5 May 2021
Ref 20355

SSD 8859
PROPOSED SUBDIVISION
1111-1141 ELIZABETH DRIVE, CECIL PARK
SITE ACCESS MATTERS

Road Safety Audit Report

Proposed Development at 1111-
1141 Elizabeth Drive, Cecil Park
(SSD-8859)

Figure 3.2: Safe intersection sight distance (SISD)

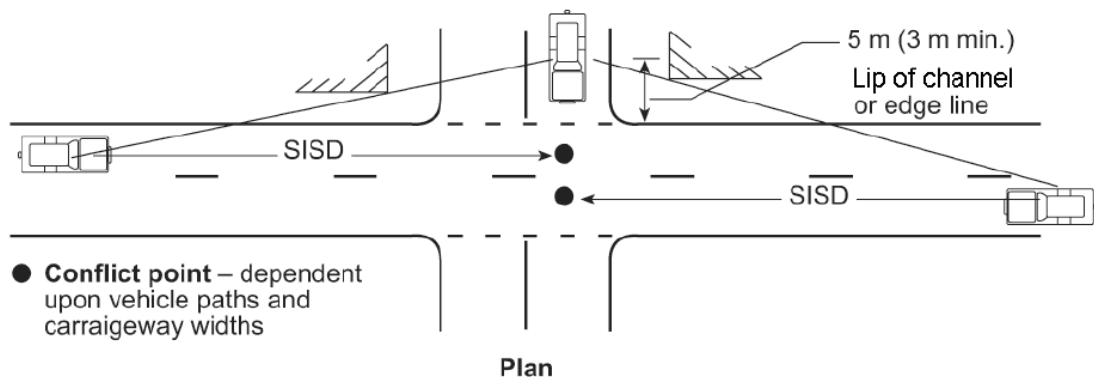
- b. The traffic report p.11, shows a proposed left turn slip lane from the realigned Wallgrove Road onto the access road (access to the subject site), which also continues after the access road to form two lanes on the realigned Wallgrove Road continuing to the intersection with Elizabeth Drive. This will potentially cause significant safety and operational issues as traffic turning in and out onto and from the access road would assume these vehicles on the kerb side lane are turning left onto the access road, however, these vehicles may choose to continue to travel straight on Wallgrove Road. Further, visibility and sightlines for traffic exiting from the access road would also be restricted by traffic travelling along the kerb side lane before the proposed access road.

The critical turning movement for driver visibility is the left turn out of the proposed new subdivision road onto the new realigned Wallgrove Road.

Reference to Austroads *Guide to Road Design Part 4A: Unsignalised and Signalised Intersections*, Section 3.2.2 sets out the design requirements for SISD, which is the minimum sight distance which should be provided on the major road at any intersection. Diagrammatically, SISD is illustrated in the Austroads extract below.

Proposed new “half seagull” intersection treatment

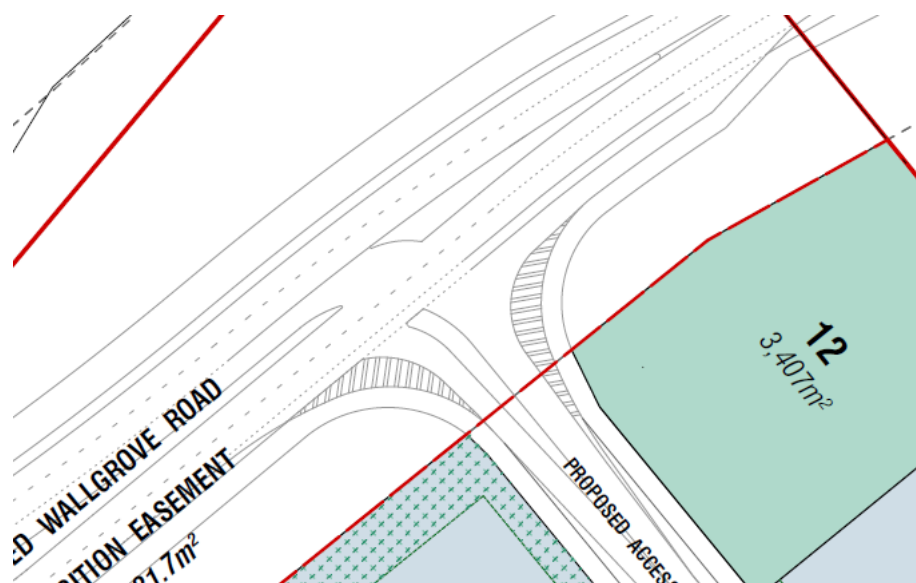
- sight distance for vehicles turning left out of the subdivision road back onto Wallgrove Road, particularly in the instance where a vehicle is also turning left into the subdivision road whilst utilising the left-turn slip lane,
- the width and kerb return radii at the proposed new subdivision intersection and the angle at which smaller vehicles may be placed as they turn left out of the subdivision road back onto Wallgrove Road, and
- the offset distance between the proposed new subdivision intersection and the start of the right turn bay at the new Wallgrove Road & Cecil Road traffic signals

With respect to *MU Group's* sight distance concern, the RSA notes that a SISD of 150m is achieved when the left-turn slip lane is clear, however is reduced to 84m when a left turning vehicle is *within* the slip lane.

As noted in the foregoing, the road design of the future Wallgrove Road realignment is still a work-in-progress, however it is evident that the 151m SISD requirement can be achieved. In terms of the reduced SISD when a left turning vehicle is *within* the slip lane, this “moment in time” will be short-lived. Based on the traffic generation potential of the subdivision, there will not be a constant procession of left turning vehicles into the subdivision. Once the left turning vehicle has entered the subdivision, the available visibility will return to 151m. Furthermore, a left turning entering vehicle does not automatically grant a left turning exiting vehicle right-of-way to pull out into the main road traffic flow. The left turning exiting driver must display caution at all times and wait until they are completely satisfied there is a sufficient gap in traffic flow before exiting, as per the NSW Road Rules. This arrangement is typical and commonplace in today's urban environment and considered acceptable.

With respect to *MU Group's* concern regarding the angle of exiting vehicles, this is simply rectified by the inclusion of linemarking, as illustrated in the screenshot image of the concept plan below. The extent of linemarking illustrated in the concept plan is based on the swept turn path requirements of an 8.8m long MRV truck, noting that the intersection has been designed to accommodate B-Triples. Larger trucks will therefore traverse over the linemarking which is also commonplace and acceptable in today's urban environment.

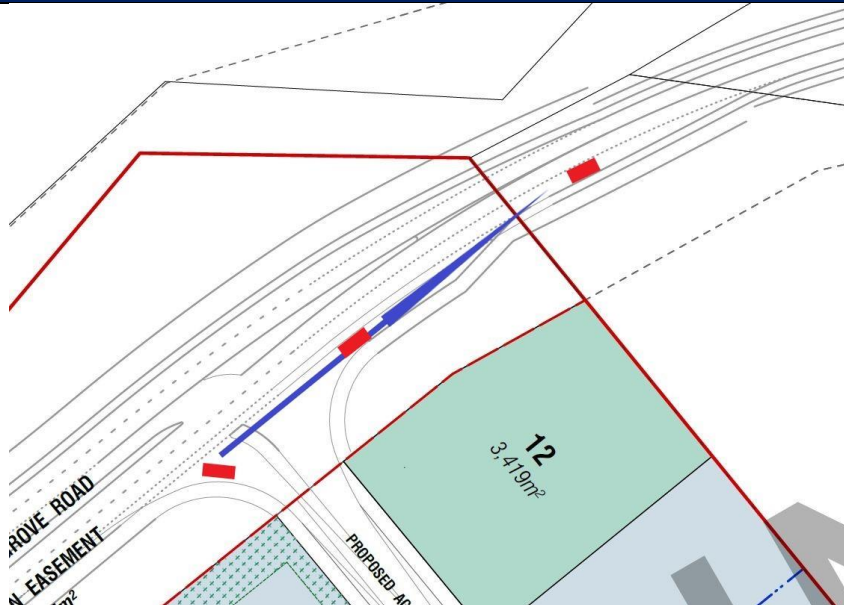
Ref No.	Photos / Site Description / Safety Issue	Description of risk to road safety (Reason why this is a safety issue)	Road Safety Audit Category	Probability	Severity	Risk Rating
1	 <p><i>Design plan showing left turning vehicle from proposed site access.</i></p> <p><i>Austrroads requirement (Guide to Road Design Part 4A, Table 3.2) for SISD at 70km/h: 151m</i></p> <p><i>SISD Achieved in current design with left turning vehicle: 84m</i></p> <p><i>SISD Achieved in current design with left turning vehicle: 150m</i></p>	<p>Safe intersection sight distance for left turning vehicles out of the access road is not achieved to southbound vehicles in Wallgrove Road. Drivers may become impatient and pull out into the southbound travel lane on Wallgrove Road with insufficient gaps in the traffic causing rear-end and intersection type crashes. This issue could be exacerbated by the vertical alignment on Wallgrove Road (not assessed under this safety audit) as well as the presence of vehicles turning left into the development.</p> <p>It is noted that other options have proposed an intersection further north on Wallgrove Road. This does not improve the safety risk described above due to the presence of the horizontal curve in Wallgrove Road and the terminating leg of the T-intersection being on the inside of the curve.</p>	Intersections	Yearly	Serious	Medium

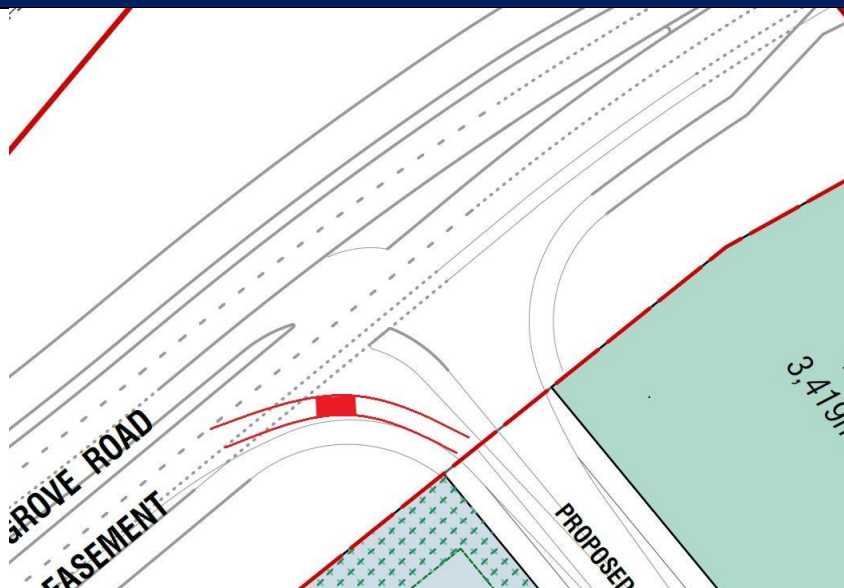
Ref No.	Photos / Site Description / Safety Issue	Description of risk to road safety (Reason why this is a safety issue)	Road Safety Audit Category	Probability	Severity	Risk Rating
2	 <p>Design plan showing left turning vehicle following kerb line and stopping at the give way line.</p>	The width and kerb return radii at the access road exit appears to be excessive. This will result in vehicles stopping at the give way line at an undesirable angle to oncoming traffic, increasing the likelihood of crashes highlighted in Risk 1. Drivers may also attempt to turn two abreast given the significant width at the intersection or illegally make a right turn out of the proposed access road resulting in right-through and rear-end crashes.	Intersections	Yearly	Serious	Medium

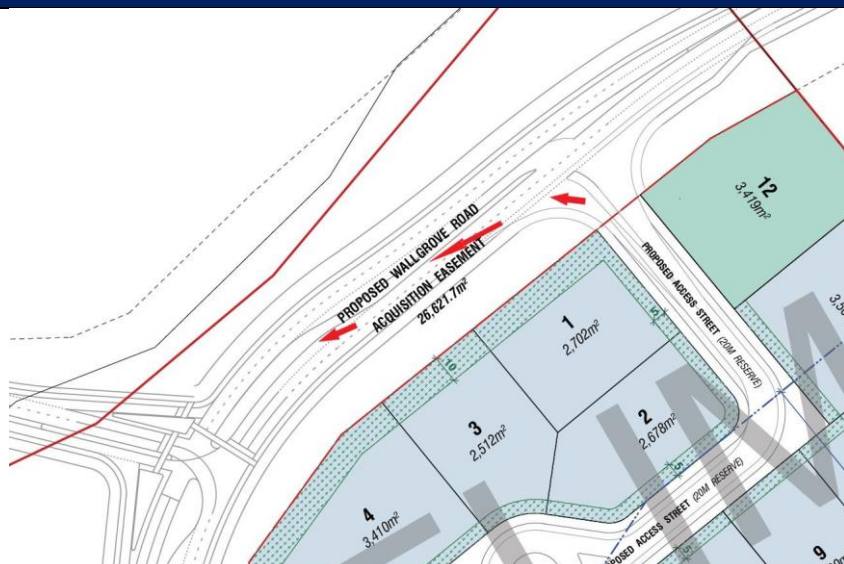
Ref No.	Photos / Site Description / Safety Issue	Description of risk to road safety (Reason why this is a safety issue)	Road Safety Audit Category	Probability	Severity	Risk Rating
3	 <p><i>Design plan showing vehicle path from the site access to the right turn bay for Cecil Road.</i></p>	Turning left out of the development access road and right into Cecil Road requires attaining a suitable gap in the southbound traffic on Wallgrove Road and then changing across one lane to enter the right turn bay. The distance available to carry out this sequence of manoeuvres is insufficient, and drivers may have to force their way through. This disruption to the traffic flow may be worsened if the right turn bay has several vehicles already waiting in it. Rear-end and lane change crashes could occur as a result of this geometry.	Intersections	6 Monthly	Moderate	Low

DRAWING TITLE
SIGHT DISTANCE CHECK
Vehicles Turning out of Access Road onto Future Wallgrove Road

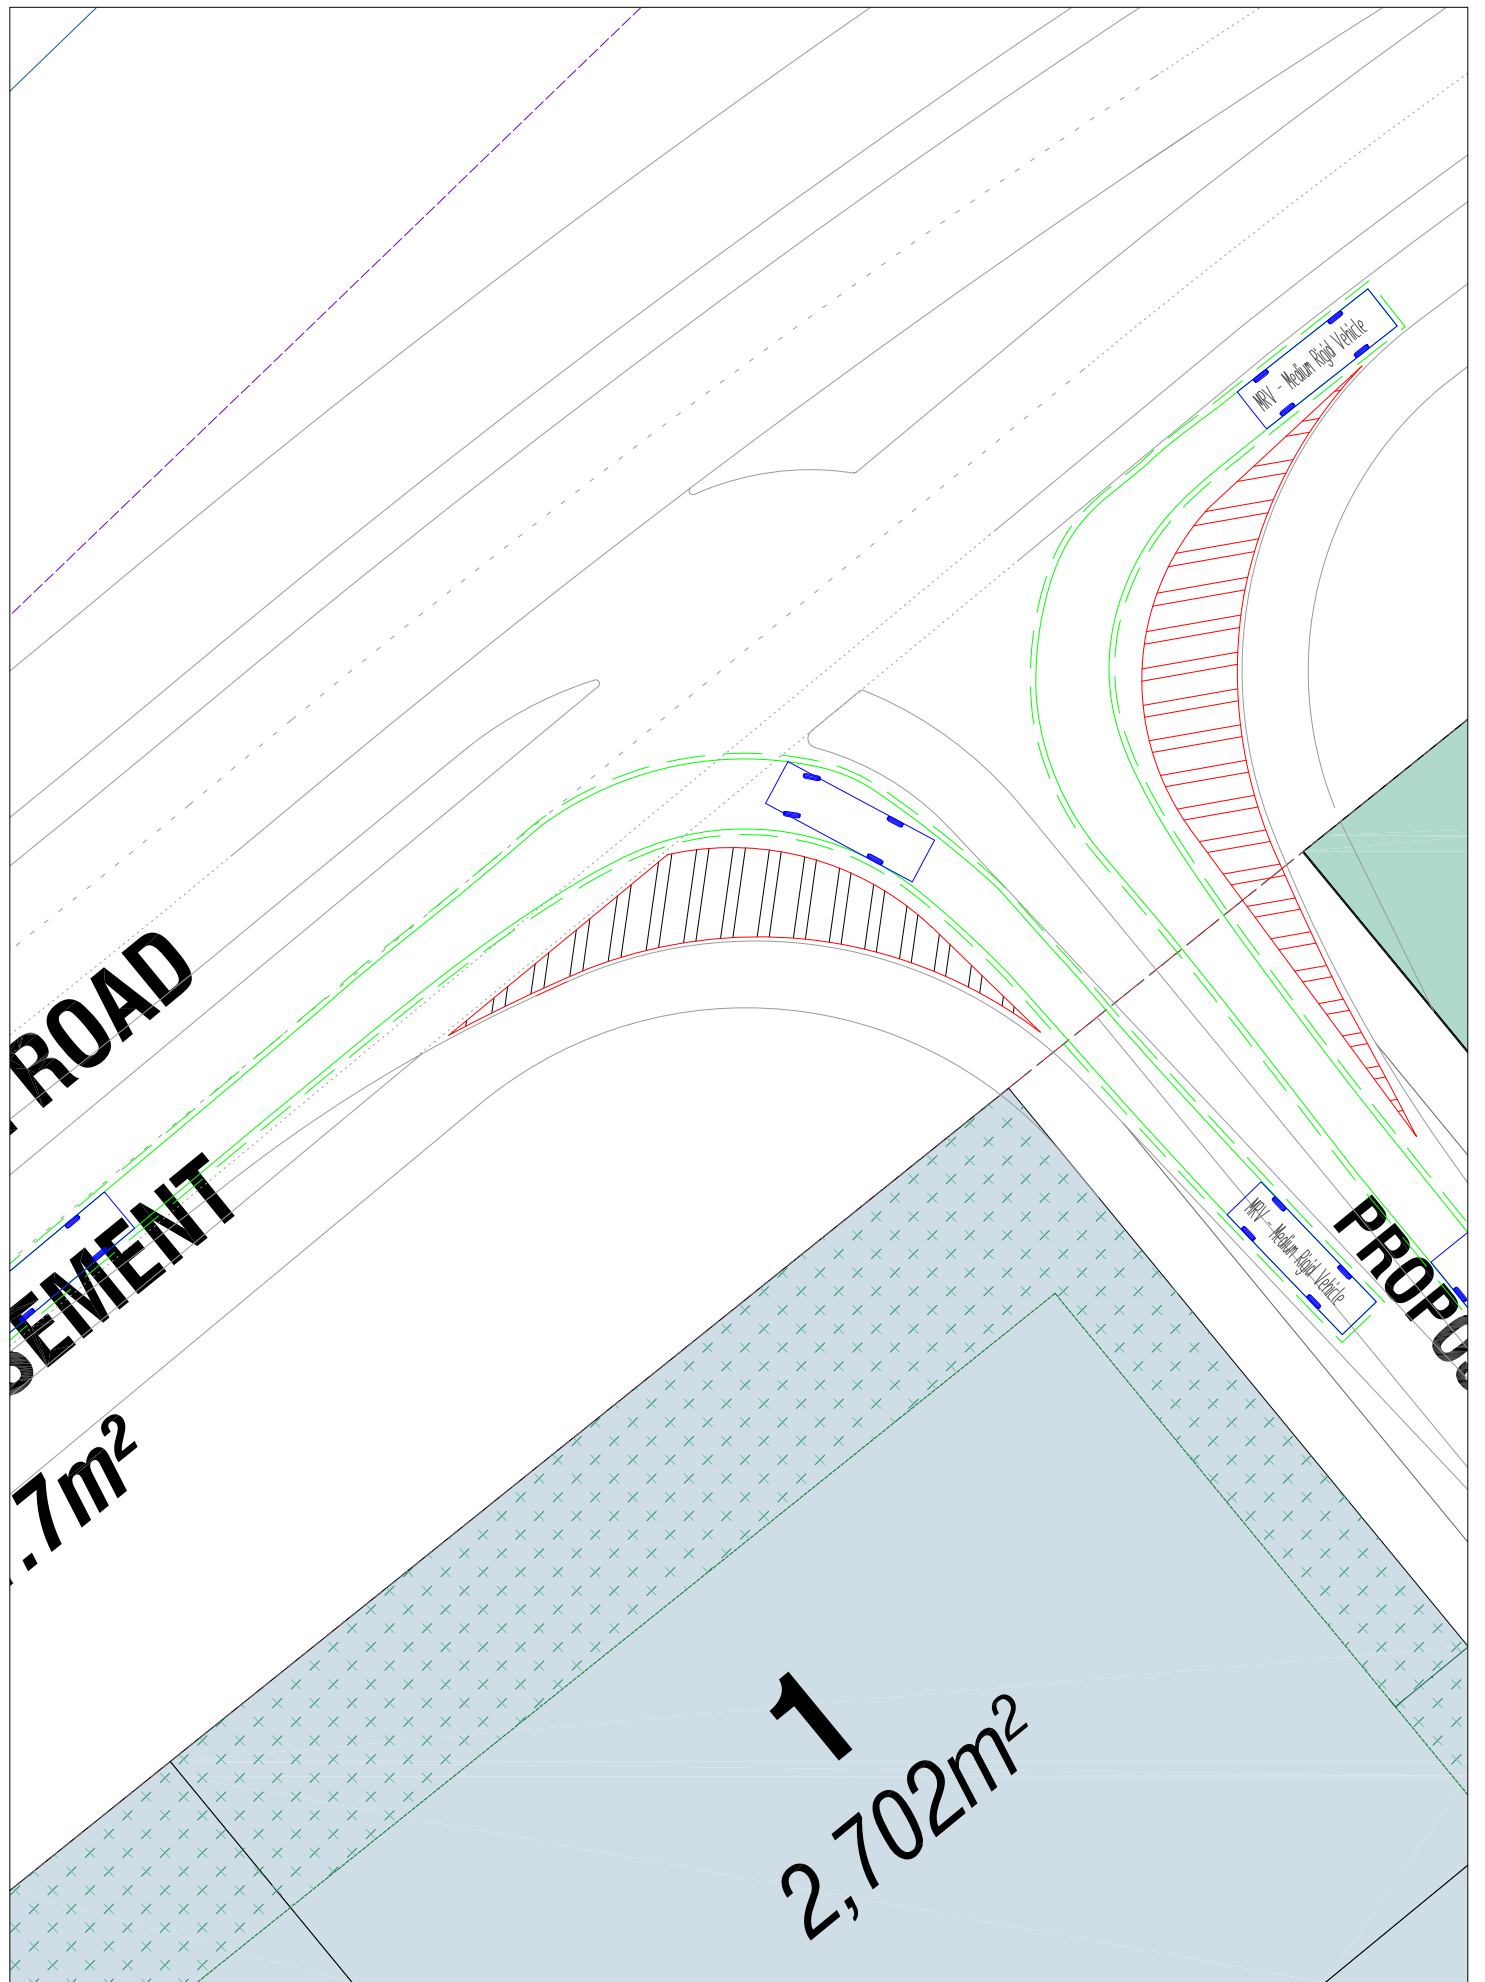
- a. The proposed access to the site on the new realigned Wallgrove Road is located around a bend and TfNSW raises safety concerns with the sight distance at the proposed access road. A sight distance assessment should be provided to demonstrate the required sight distance is achieved.

Again, I understand the road design of the future Wallgrove Road realignment is still a work-in-progress, nevertheless a sight distance assessment is provided on the following page, indicating that the 151m SISD requirement is and can be achieved.

DRAWING TITLE
 8.8M MRV TRUCK TURNING PATH
 Exiting Proposed Access Road

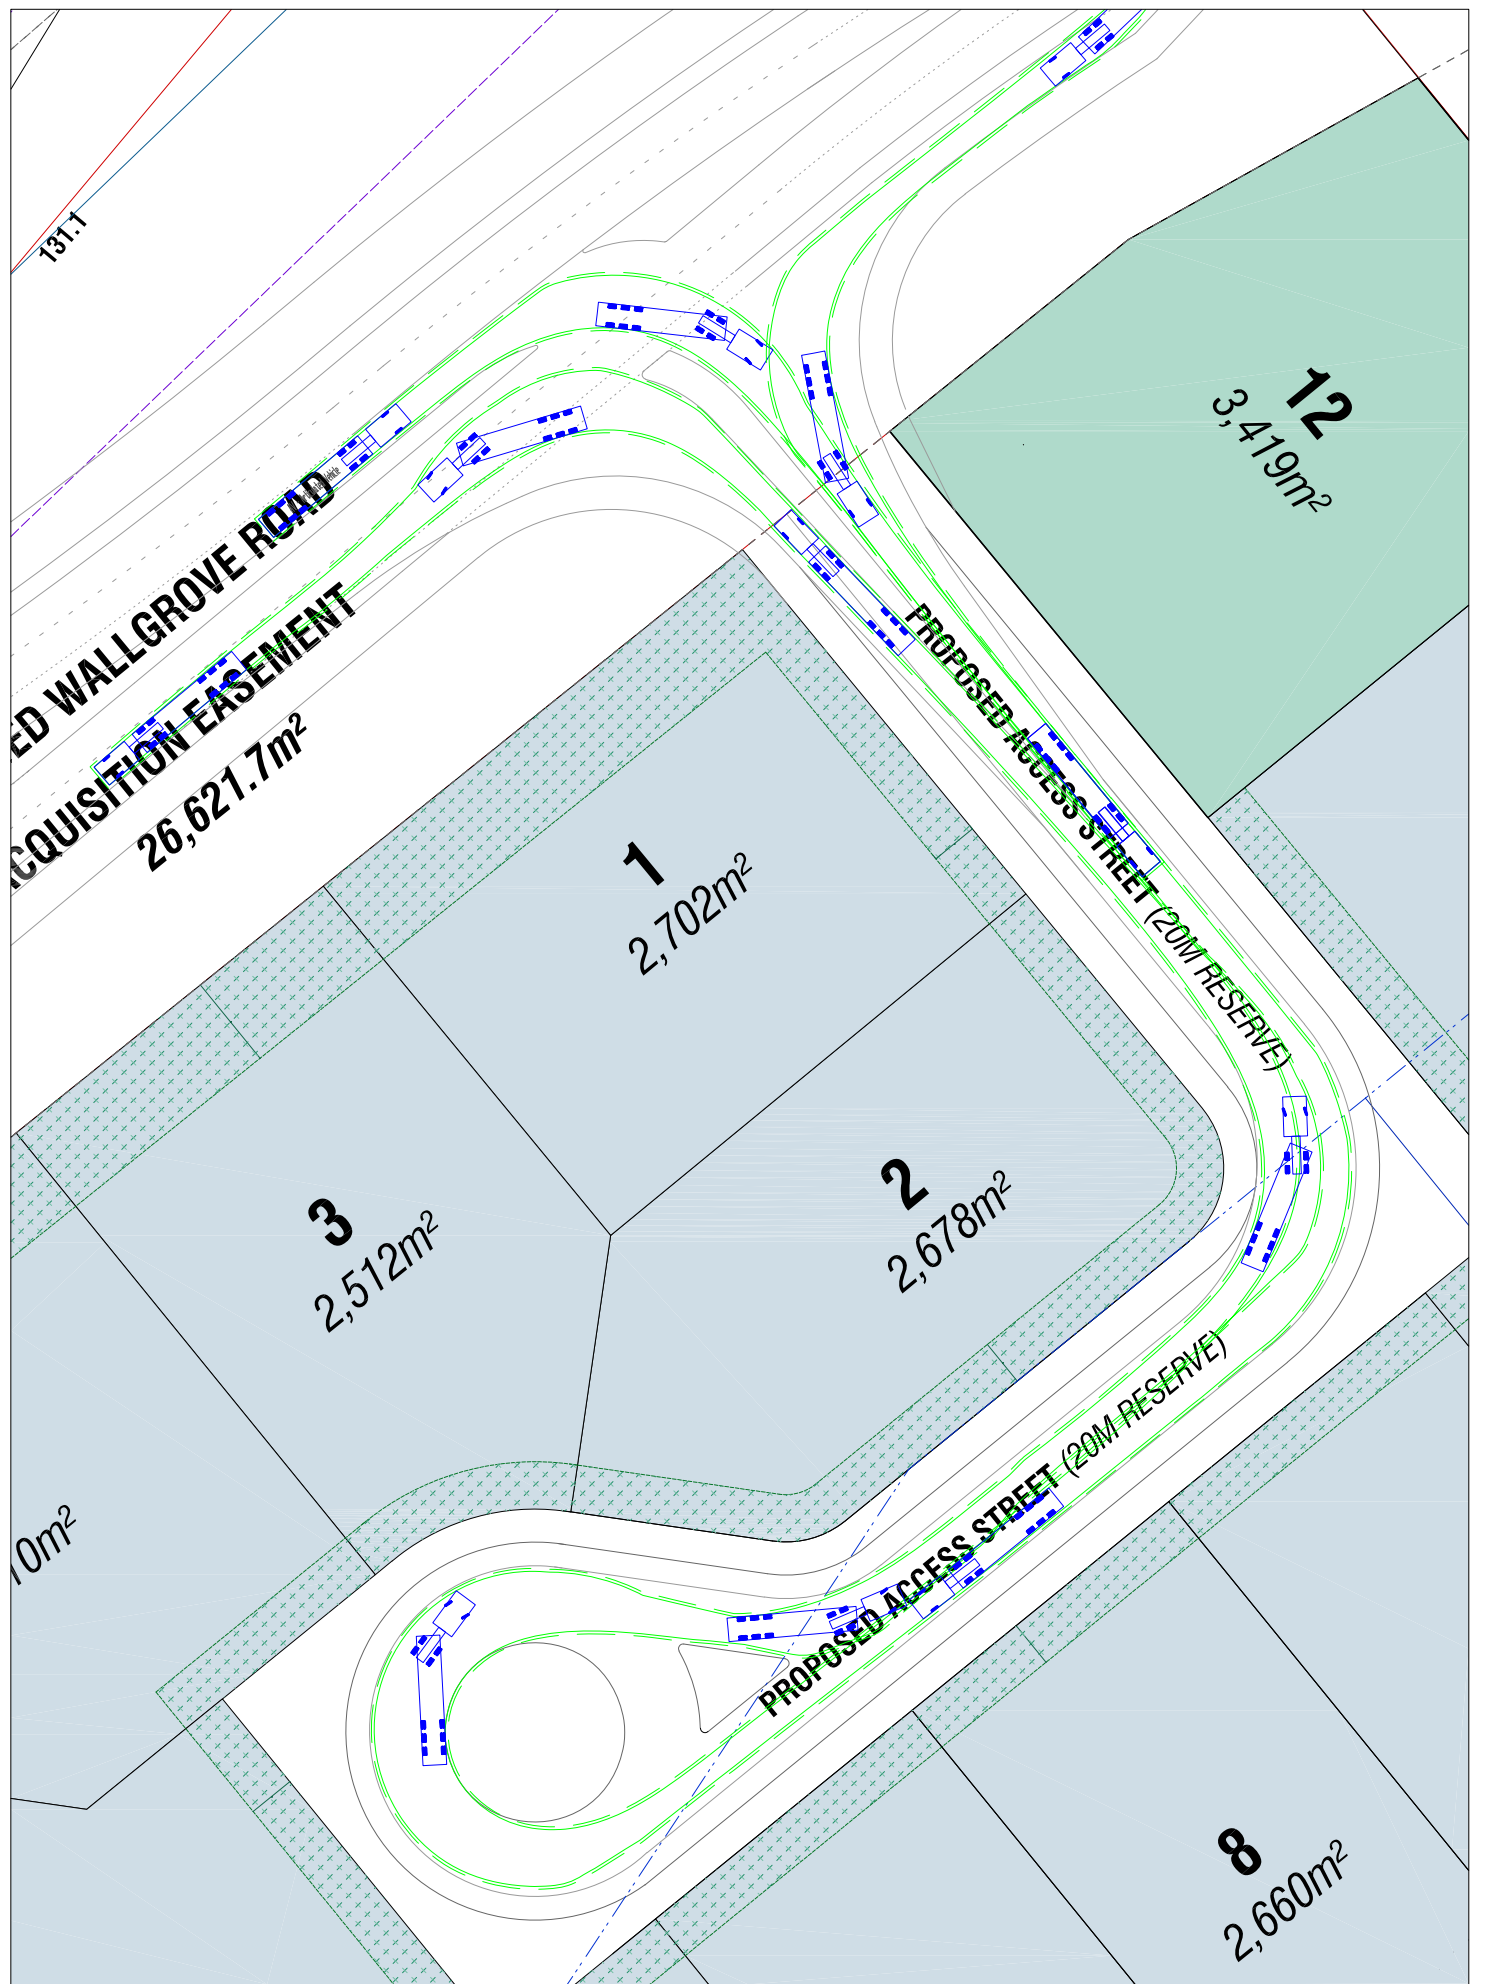
- a. Realigned Wallgrove Road / new site access road
 - b. Realigned Wallgrove Road / Cecil Road
 - c. Realigned Wallgrove Road / Elizabeth Drive
5. A swept path analysis for the largest vehicle accessing the site should be provided.

In addition to the two abovementioned vehicles, swept turn paths were also undertaken of an 8.8m long MRV “service vehicle” in order to determine the appropriate extend of linemarking required to delineate smaller vehicles into and out of the subdivision.
